Petition No. 1222 Windham Solar, LLC Fisk Road Hampton, CT Interrogatories Windham Solar LLC, Responses

CSC APPROVAL RACKING PROFILE

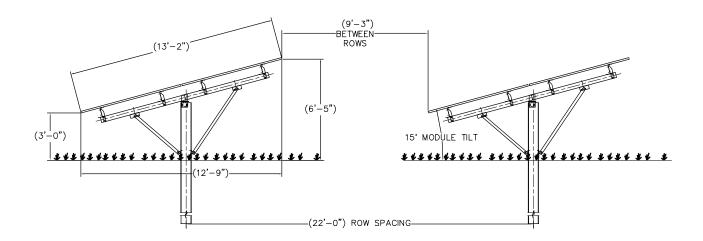
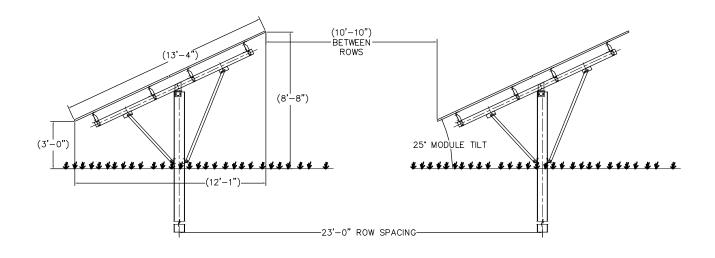
degrees) angle. Sheet No. 4 shows a 22-foot row spacing (center to center). Exhibit C shows a 23-foot row spacing. Please indicate which row spacing is correct and consistent with the DEEp-approved General Permit and correct the appropriate sheet.

Please update Sheet No 4 to depict the corrected Racking Profile Detail with the updated (25

The row spacing will be 23' and can be found in the original D&M submission Exhibit C, in SG101 and SG102. The solar module effective imperious calculations included a 15-degree tilt and a 22-foot post to post spacing for the stormwater design of the project. These values were chosen as a conservative approach for stormwater basin sizing resulting in a higher effective impervious, and ultimately more conservative stormwater basin design. The final effective impervious for the facility

has been reduced approximately 80% with the final racking design. Attached as Exhibit C is the effective impervious hydrology calculation document as well as a comparison exhibit to illustrate the final racking design versus the approvals associated with the initial petition and DEEP submissions.
